<b>Docket Number:</b>	16-AFC-01C
<b>Project Title:</b>	Stanton Energy Reliability Center - Compliance
<b>TN #:</b>	229859
<b>Document Title:</b>	STAFF APPROVAL OF PROPOSED CHANGE
<b>Description:</b>	N/A
<b>Filer:</b>	Cody Goldthrite
<b>Organization:</b>	California Energy Commission
<b>Submitter Role:</b>	Commission Staff
<b>Submission Date:</b>	9/26/2019 10:53:52 AM
<b>Docketed Date:</b>	9/26/2019

## **STAFF APPROVAL OF PROPOSED CHANGE STANTON ENERGY RELIABILITY CENTER (16-AFC-01C)**

### Project Description Figure 1 Site Plan of Proposed Laydown Areas

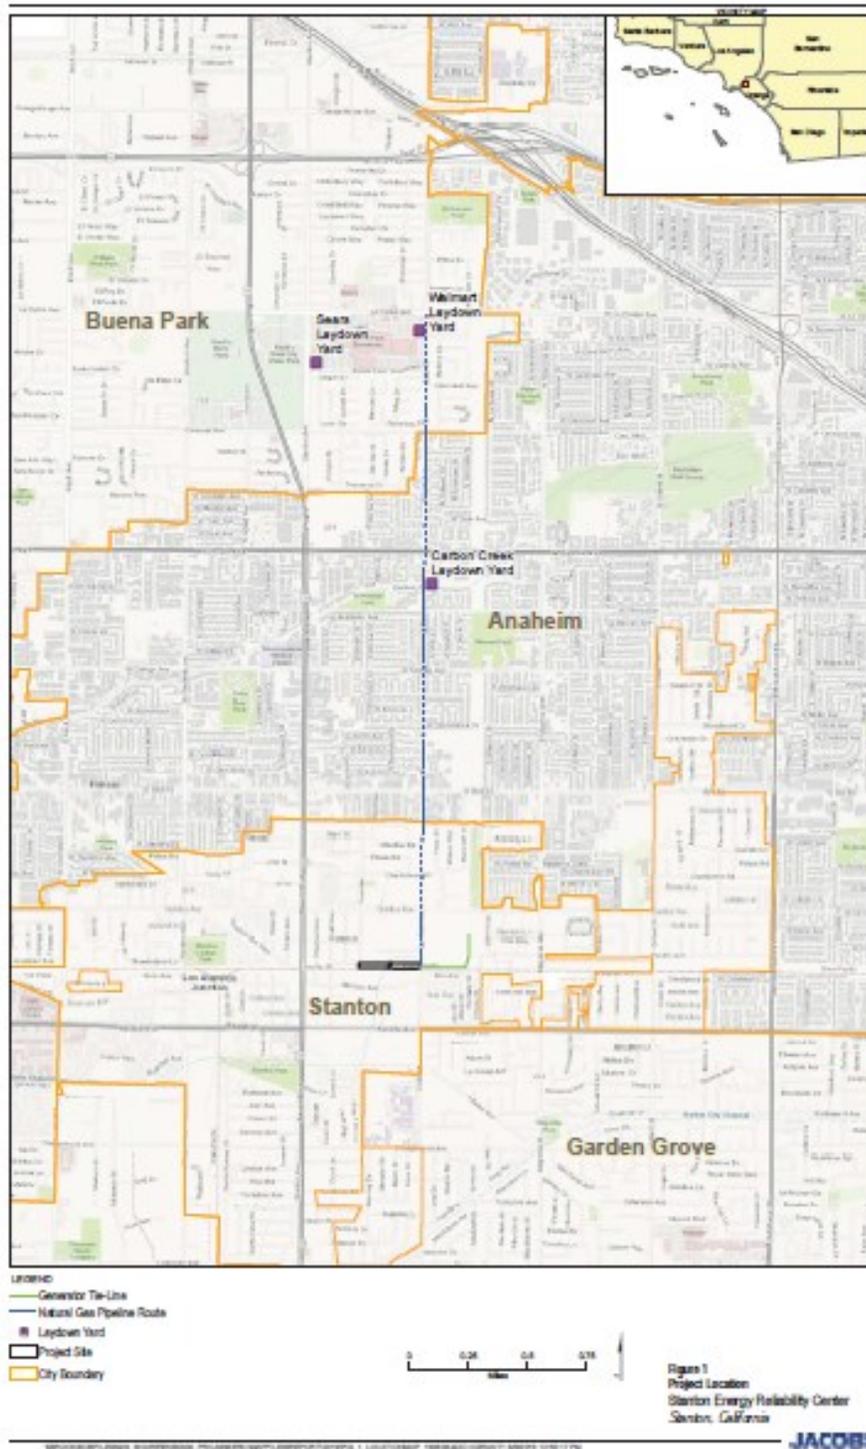
If approved, the request (TN#: 229517) would allow for two additional construction staging areas located along the gas line route. The proposed locations are:

1. An undeveloped parcel 0.3-acre in size, located northeast of Schweitzer Elementary School, on the east side of Dale Avenue, north side of Carbon Creek, in the city of Anaheim.
2. A paved parking area 1.87-acre in size, located south of Sears Tire Center, 8450 La Palma Avenue, Buena Park Place Mall, in the city of Buena Park.

Activities within the two areas include: equipment and worker parking, storage of tools and equipment in Conex boxes, pipe fittings and welding, and pipe staging and storage. Temporary security fencing would be installed at the Sears staging area.

- **Facility Design.** Installation of the temporary fencing and entrance gates must comply with the 2016 California Building Code to ensure they are adequately secured in place. Implementation of the existing **Facility Design** conditions of certification adopted in the CEC Decision would ensure this.

- **Traffic and Transportation.** The additional laydown and parking areas would not generate any additional vehicle trips beyond those already identified in the Decision. Condition of Certification **TRANS-2**, which requires a parking/staging plan for project construction, would apply and ensure that all laydown and parking would be on the designated sites and would not interfere with any traffic or transportation systems, including roadways, railways, or areas used by aircraft. Additionally, activities at the

**ENVIRONMENTAL JUSTICE - FIGURE 1**  
Stanton Energy Reliability Center - Census 2010 Minority Population by Census Block  
with CalEnviroScreen Disadvantaged Communities by Census Tracts

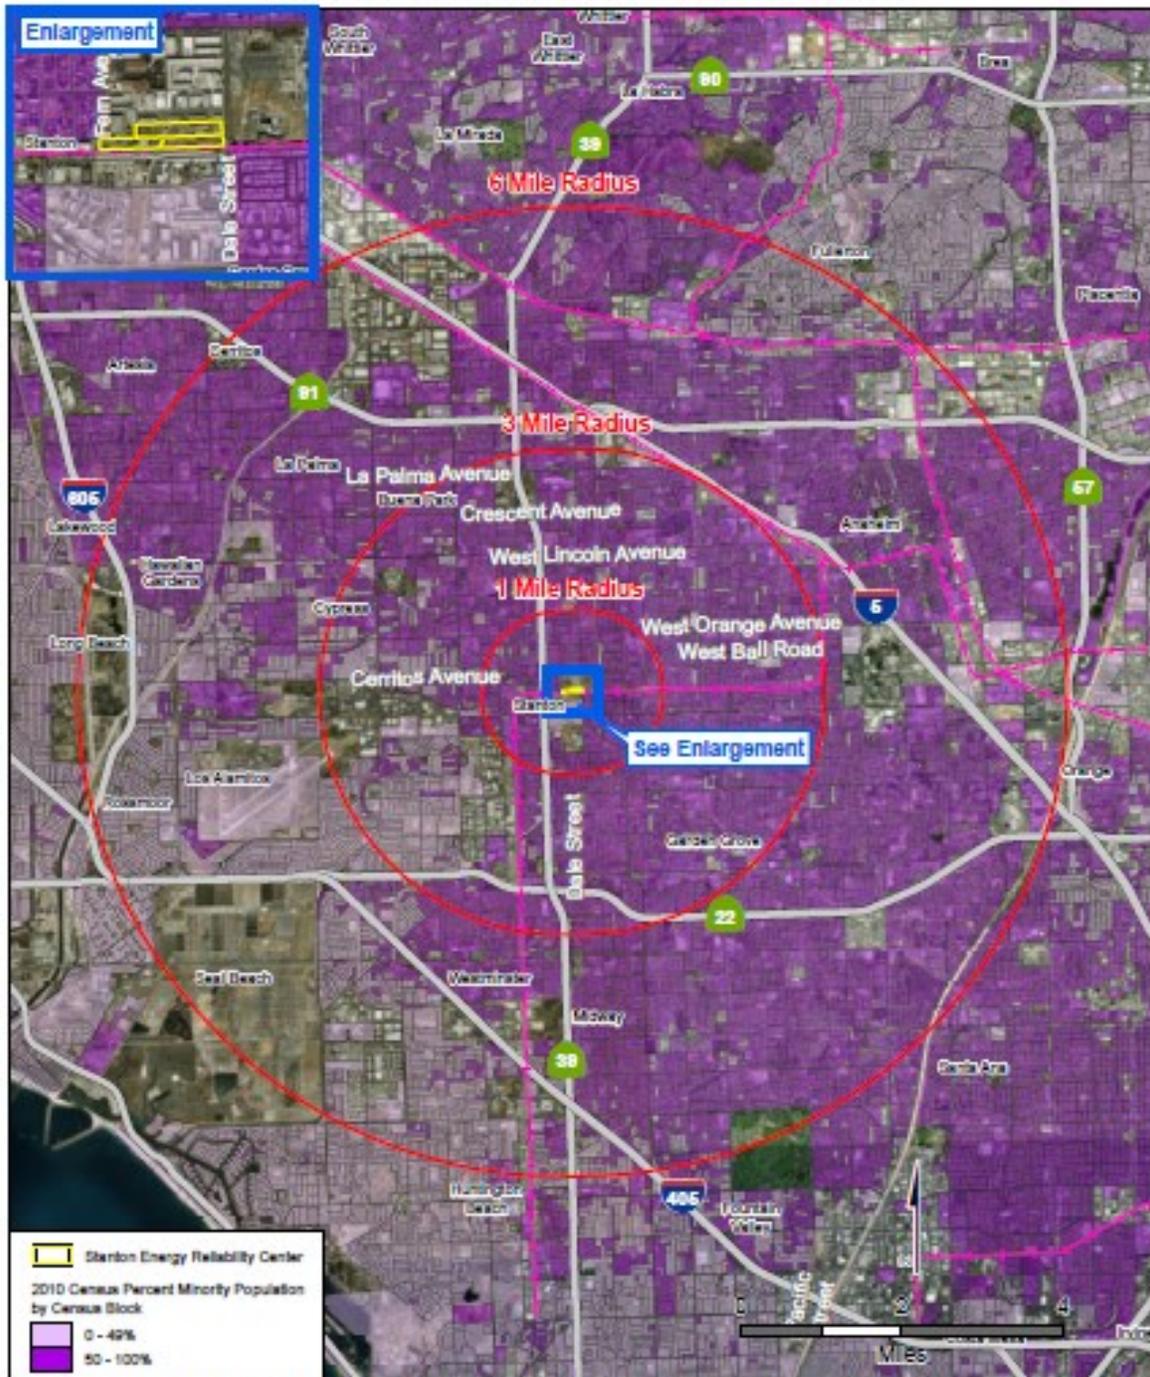
**Environmental Justice Figure 1** shows 2010 census blocks in the six-mile radius of the SERC with a minority population greater than or equal to 50 percent. The population in these census blocks represents an environmental justice (EJ) population based on race and ethnicity as defined in the United States Environmental Protection Agency's *Guidance on Considering Environmental Justice During the Development of Regulatory Actions*. Staff conservatively obtains demographic data within a six-mile radius around a project site based on the parameters for dispersion modeling used in staff's air quality analysis. Air quality impacts are generally the type of project impacts that extend the furthest from a project site. Beyond a six-mile radius, air emissions have either settled out of the air column or mixed with surrounding air to the extent the potential impacts are less than significant. The area of potential impacts would not extend this far from the project site for most other technical areas included in staff's EJ analysis.

For the technical areas affected by the project changes – Air Quality, Cultural Resources, Land Use, Noise and Vibration, Traffic and Transportation, Visual Resources, and Waste Management, staff concludes that impacts would be less than significant, and thus would be less than significant on the EJ population represented in **Environmental Justice – Figure 1 Figure 2, and Table 1.**

**ENVIRONMENTAL JUSTICE - FIGURE 2**  
 Stanton Energy Reliability Center - Boundaries Used to Identify Environmental Justice Population Based on Low Income

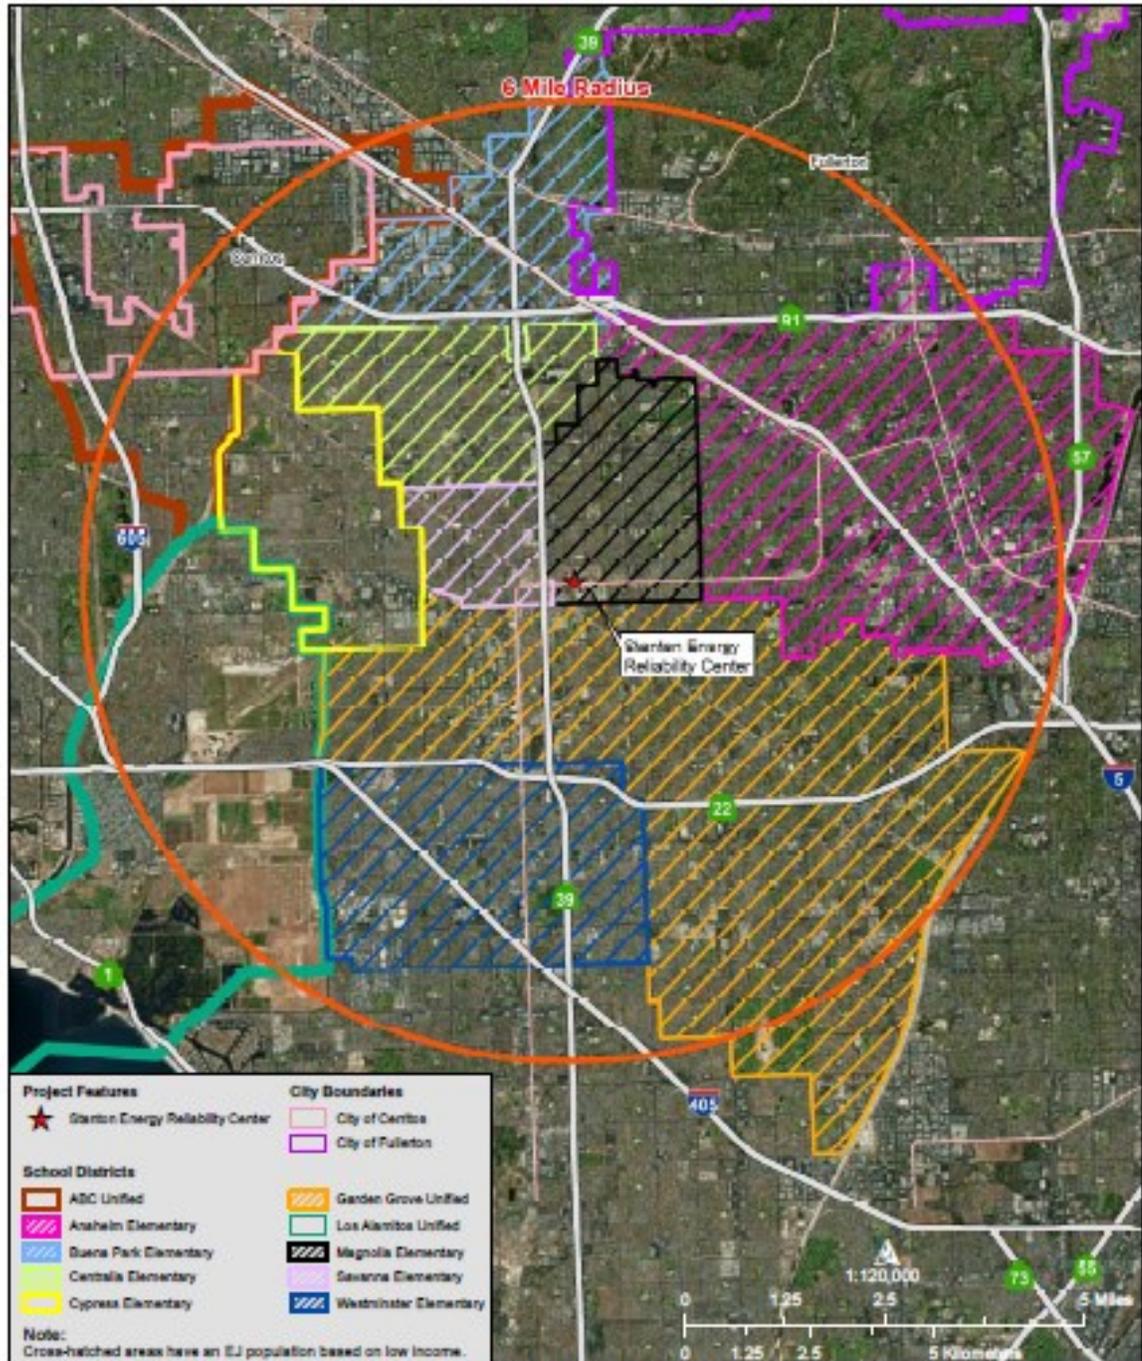
*Justice During the Development of Regulatory Actions. Environmental Justice – Figure 2* shows where the boundaries of the school districts and cities are in relation to the six-mile radius around the SERC site.
